NTSB No. CEN15MA290

Airbus Helicopters Service Bulletin No. AS350-67.00.64 (63 Pages)

SUBJECT: ROTOR FLIGHT CONTROLS - Double hydraulic servocontrols

"HYDR" test indication for double hydraulic servocontrols
 Corresponds to modification 074622

Figure 1

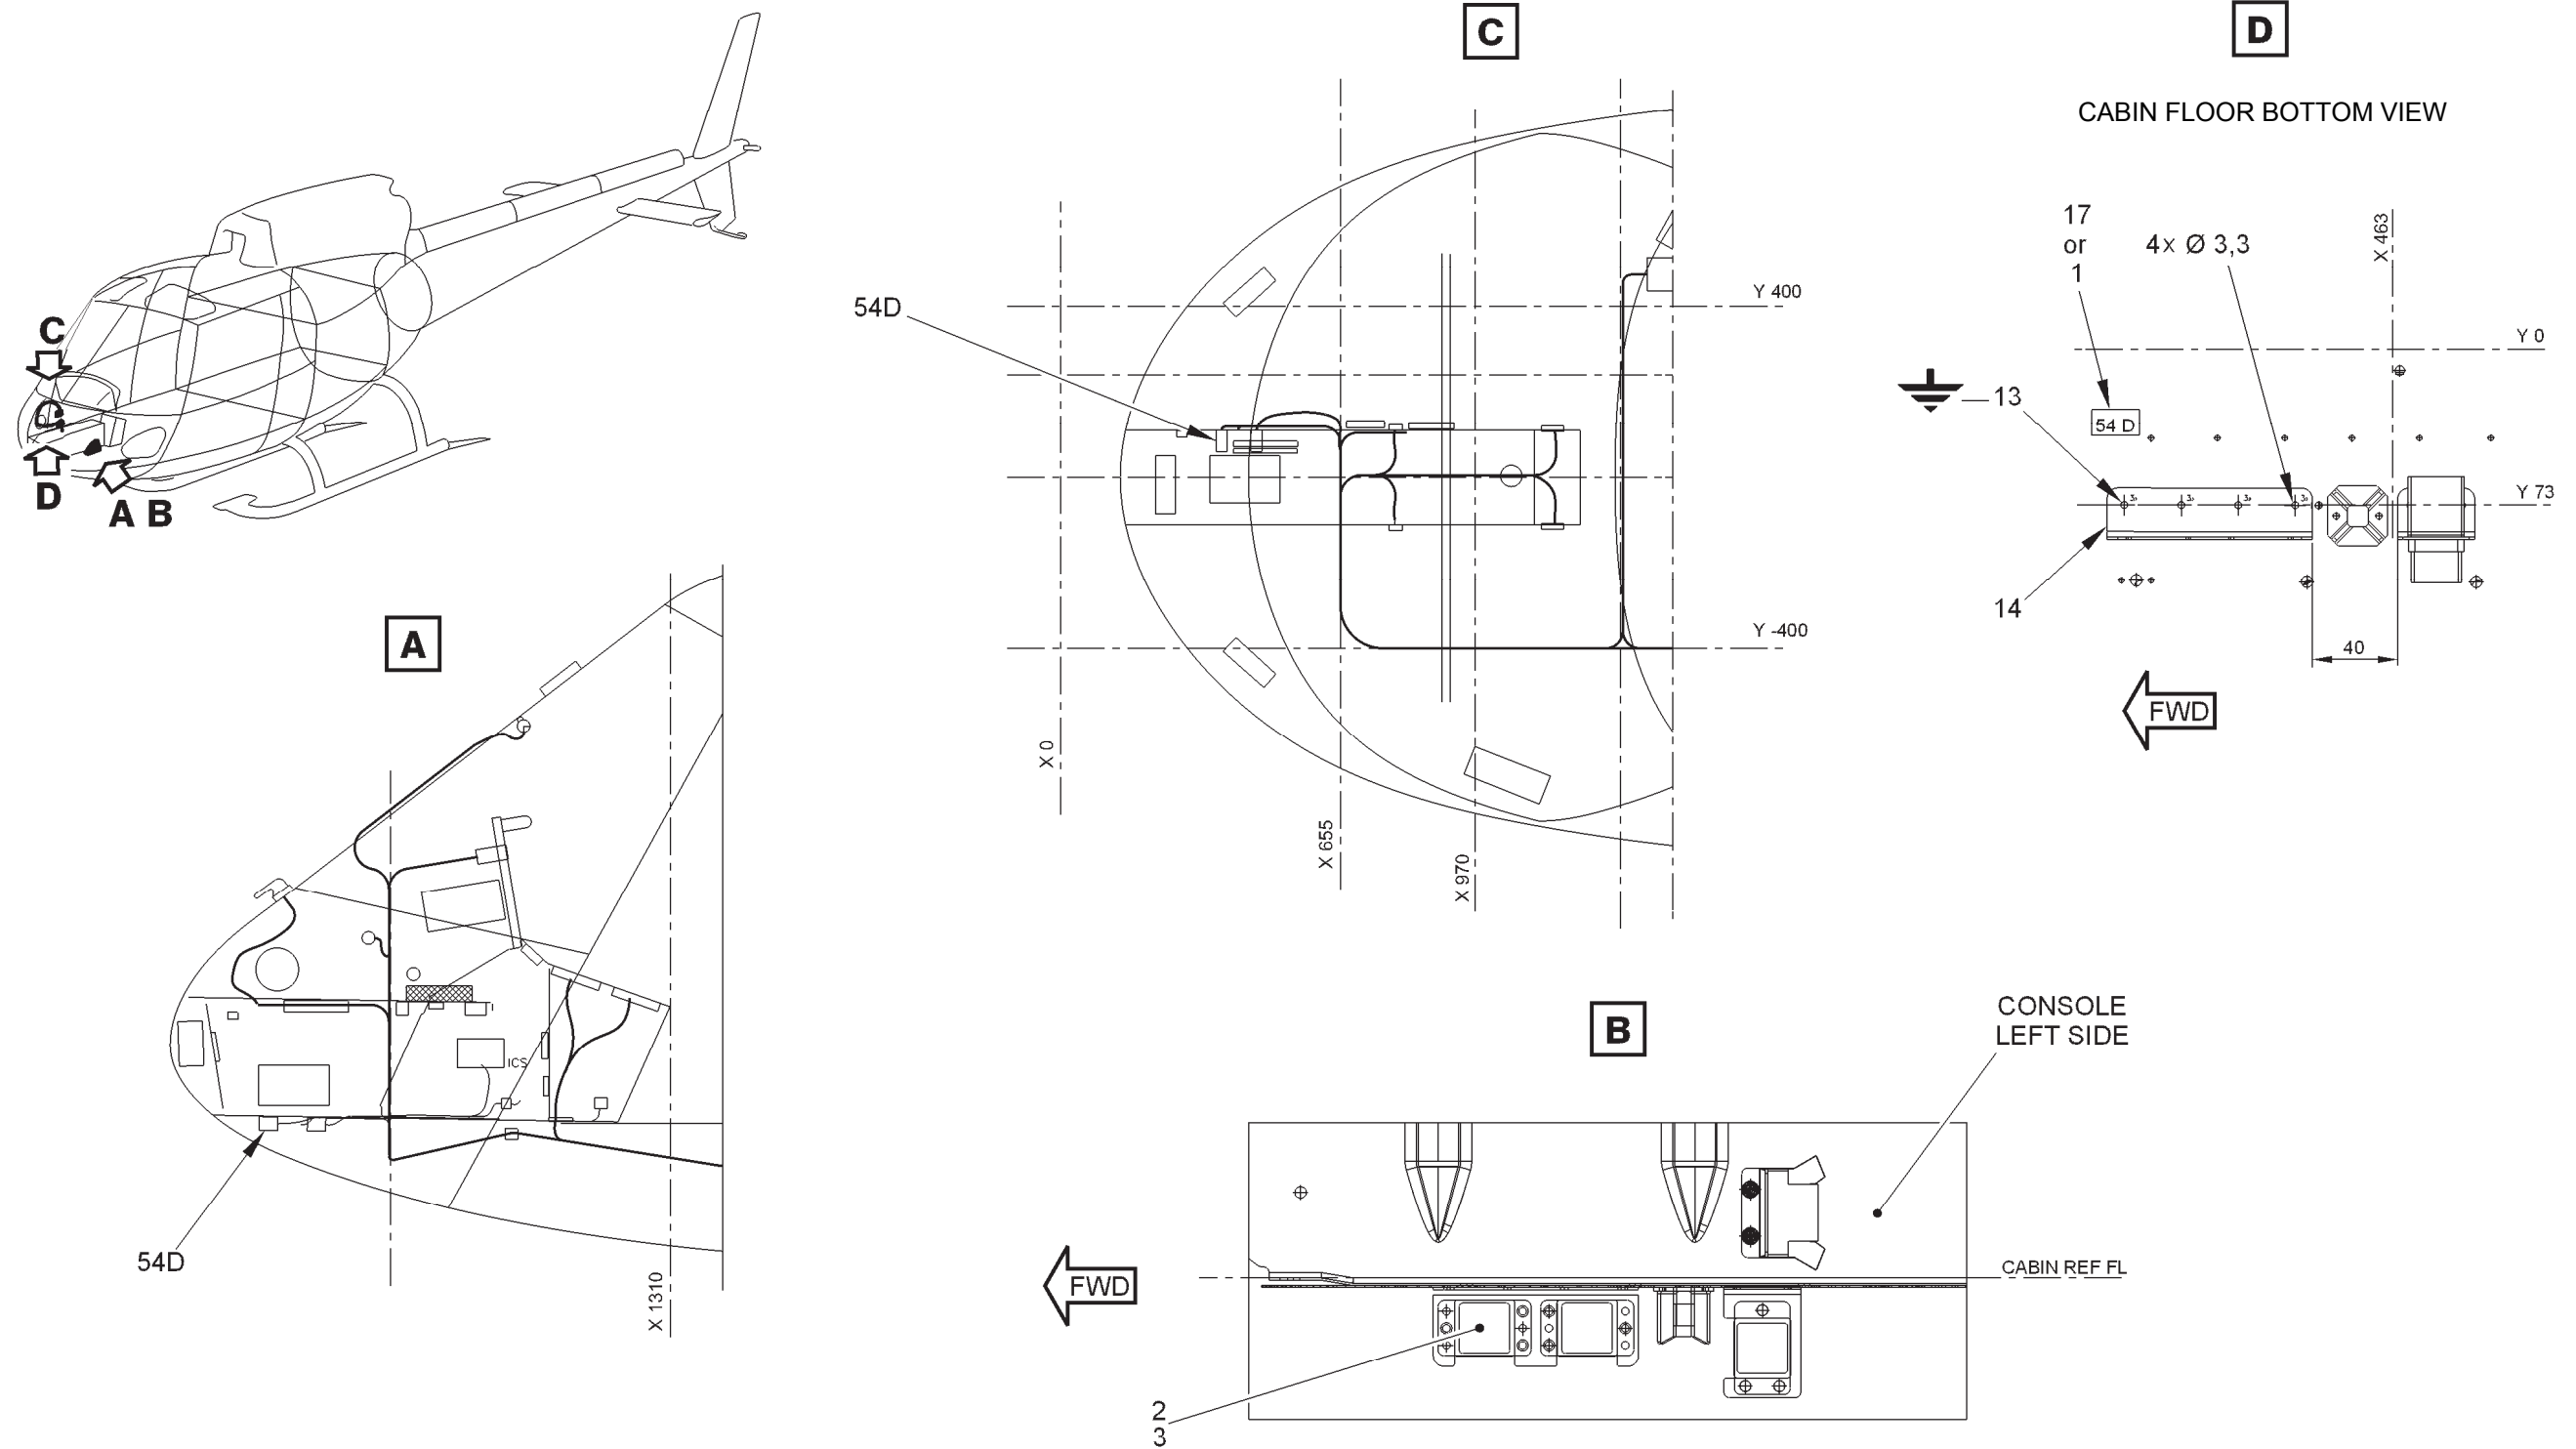
- Drill back the floor to match relay support (14) as per Detail D, Figure 1.
- Clean, deburr and electrically bond.
- Attach relay support (14) with rivets (13) as per Detail D, Figure 1.
- Bond label "54D" from set of wires and markers (1) or (17) as close as possible.

Figure 2

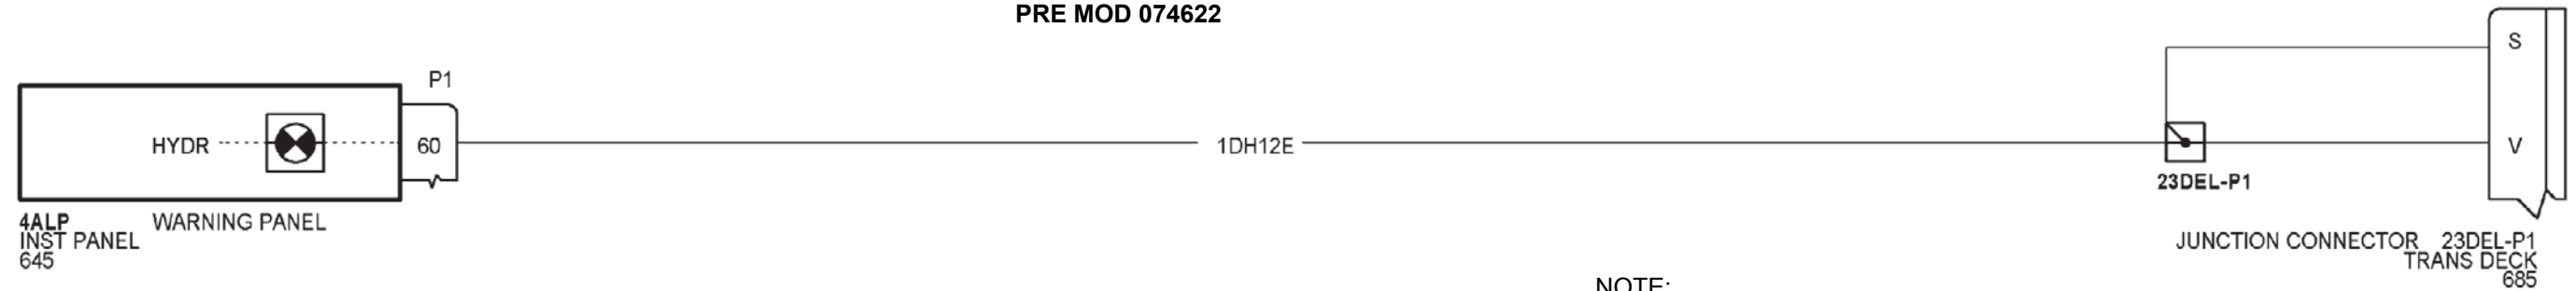
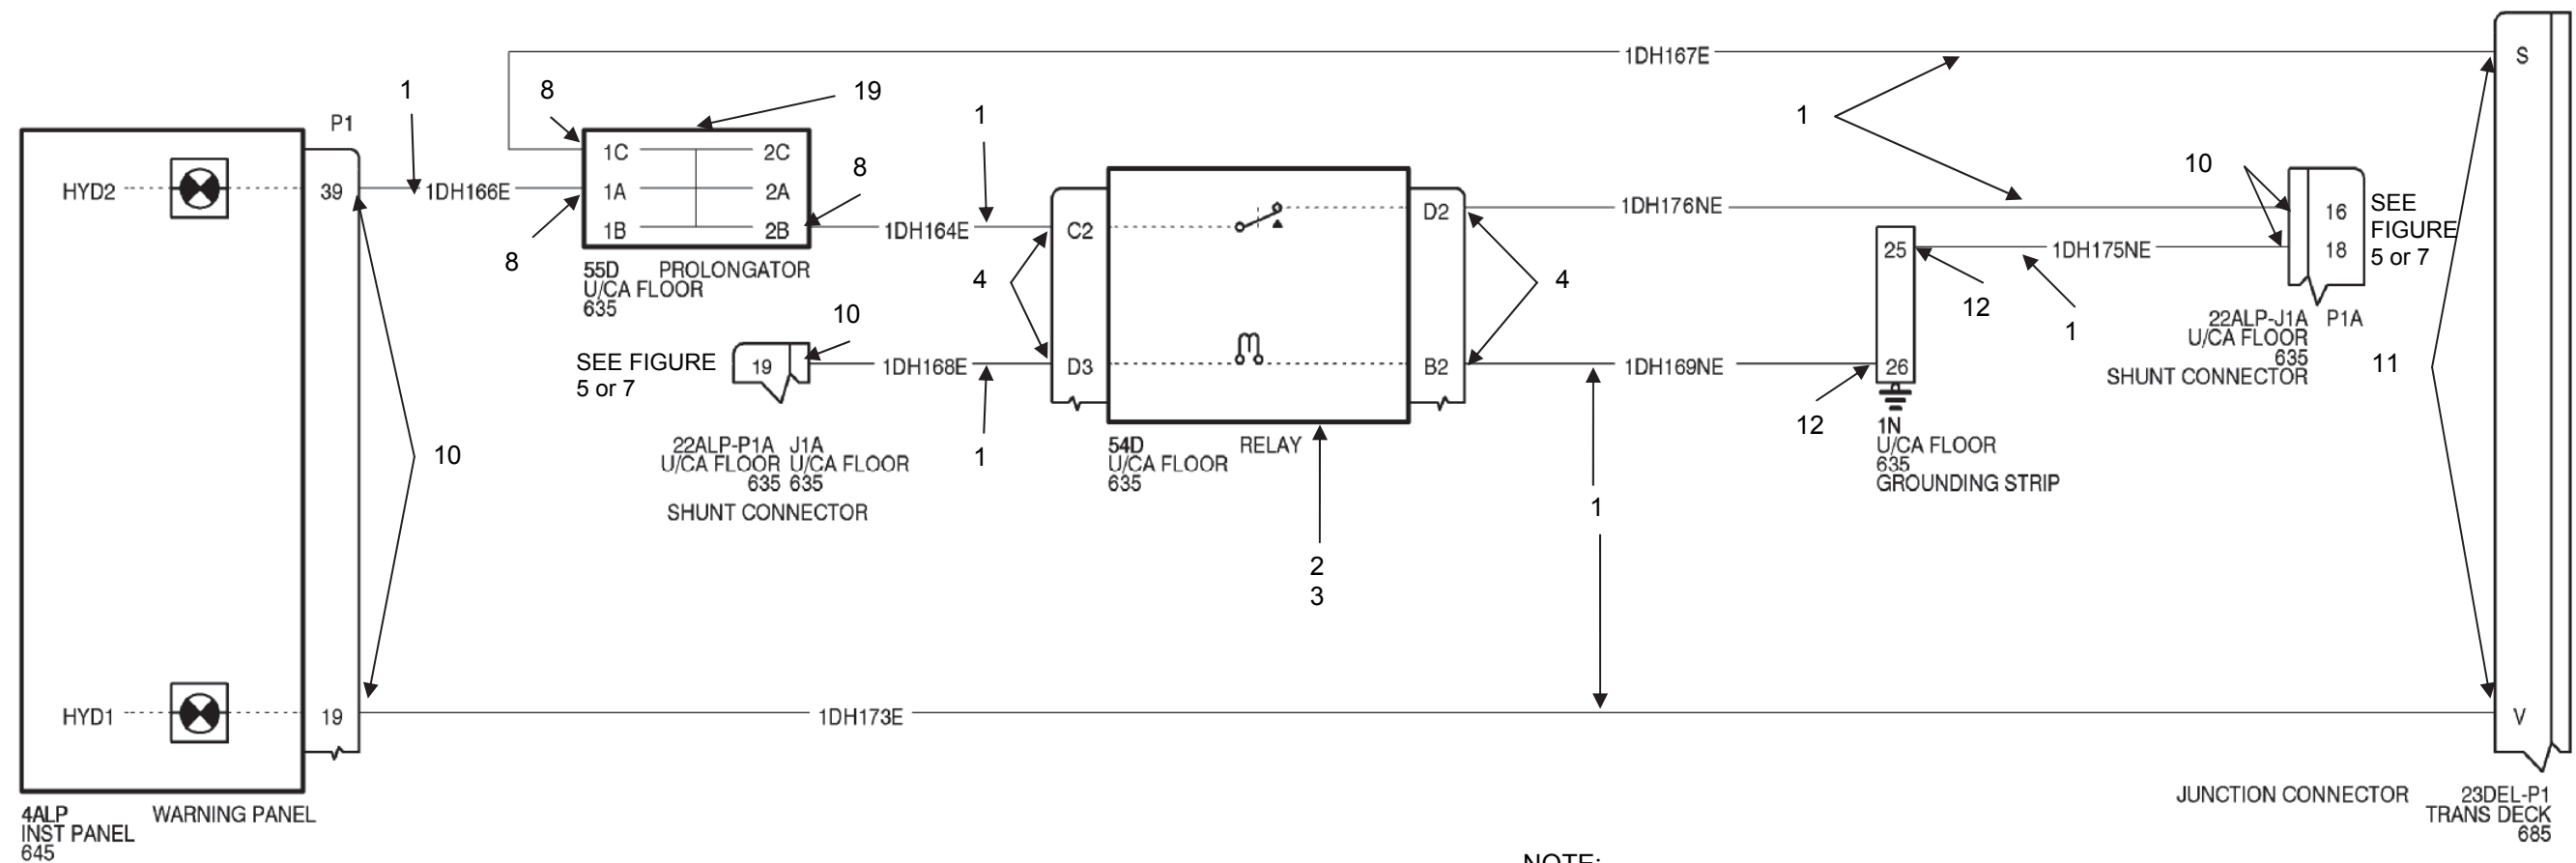
3.B.2.b.1. For helicopters POST MOD 073450 and PRE MOD 075601 (Figures 1, 2, 4, 5, 12 and 13)

- Cut and discard the binding clamps (not shown on Figures) that hold the electrical harnesses.
- Install base (3) on relay support (14) (Figure 1) with its bolts and nuts.
- Route the wiring using sets of wires and markers (1) and (33) and wire to contacts (4), (8), (10) and (11), ground contacts (12) (refer to appendix 4.A.), extensions (9) and (19), module (5) and its adapter (7), as per Figures 2, 4, 5, 12 and 13.
- Carry out a continuity test of the modified wiring.
- Install timer relay (2) on base (3).
- Attach the electrical harnesses with binding clamps (31) or (32) (not shown on Figures).

Figure 3

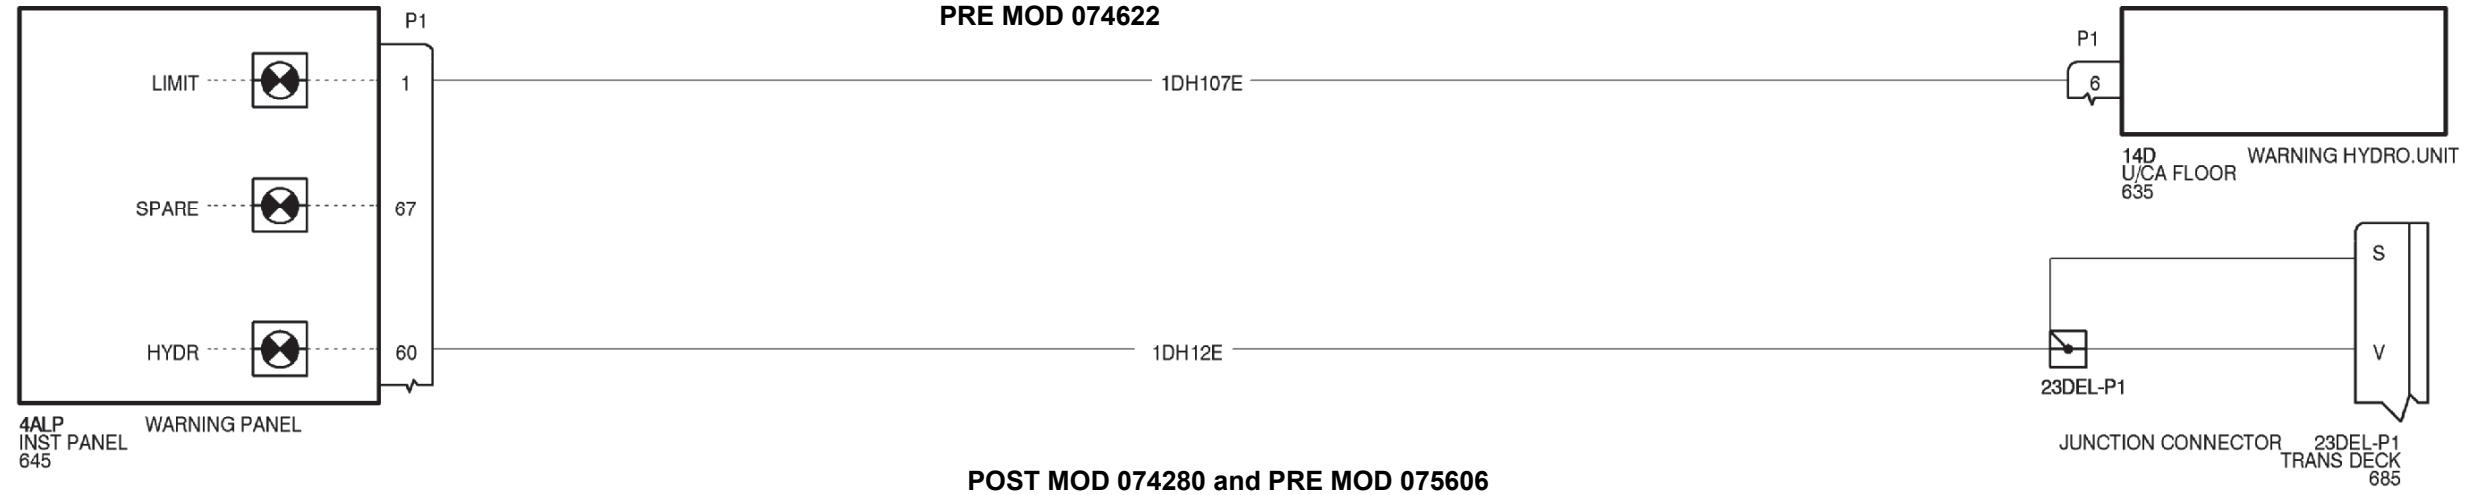
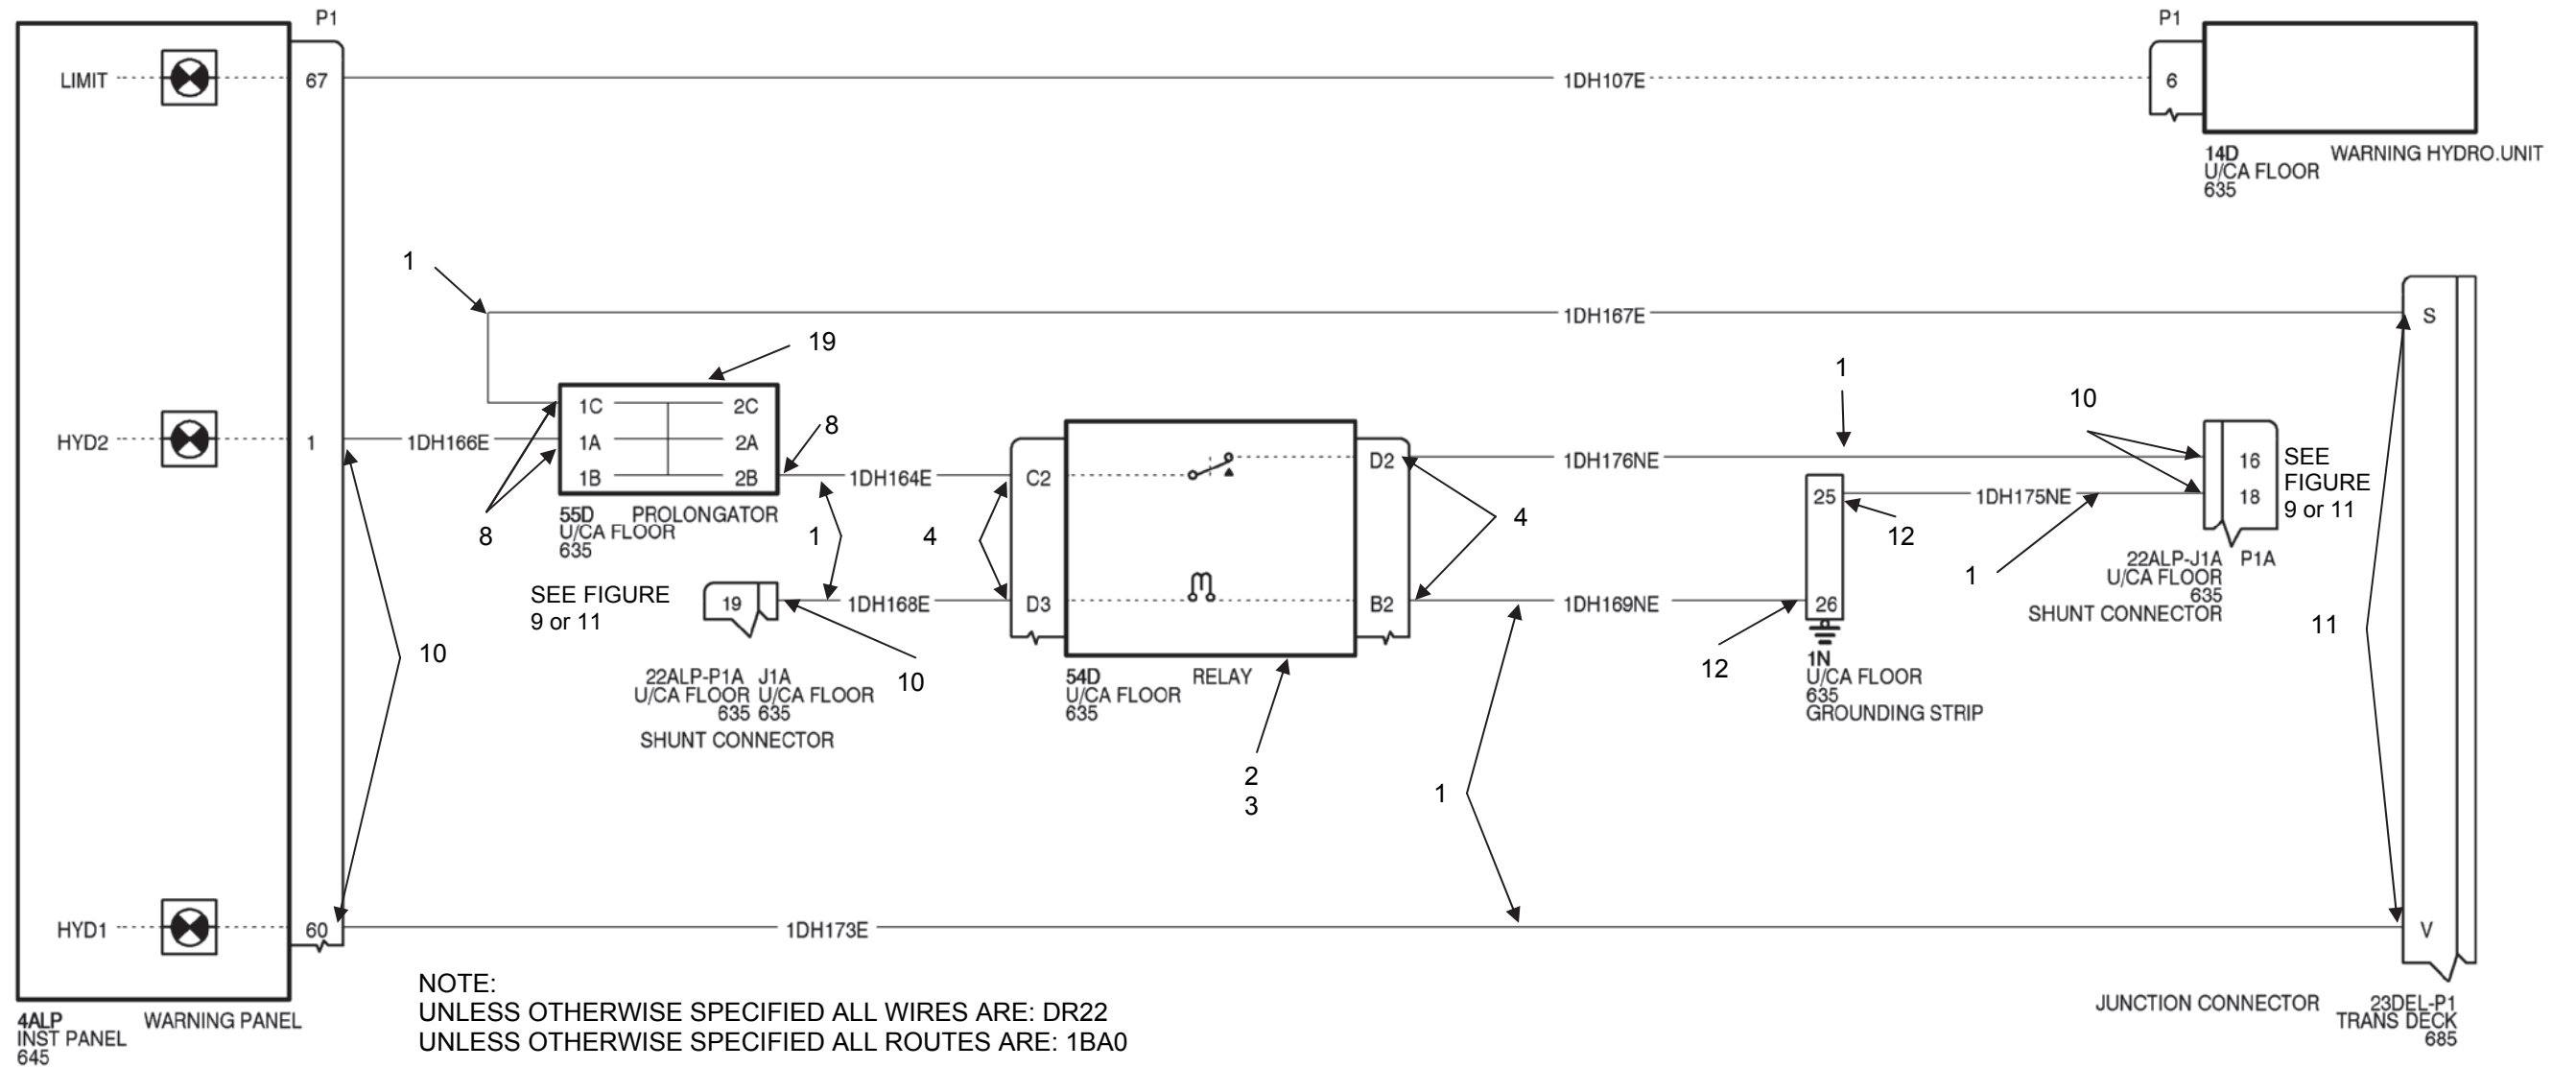
3.B.2.b.3. For helicopters POST MOD 074280 and PRE MOD 075606 (Figures 1, 3, 8 and 9)

- Cut and discard the binding clamps (not shown on Figures) that hold the electrical harnesses.
- Install base (3) on relay support (14) (Figure 1) with its bolts and nuts.
- Route the wiring using sets of wires and markers (1) and (33) and wire to contacts (4), (8), (10) and (11), ground contacts (12) (refer to appendix 4.A.), extensions (9) and (19), module (5) and its adapter (7), as per Figures 3, 8 and 9.
- Carry out a continuity test of the modified wiring.
- Install timer relay (2) on base (3).
- Attach the electrical harnesses with binding clamps (31) or (32) (not shown on Figures).
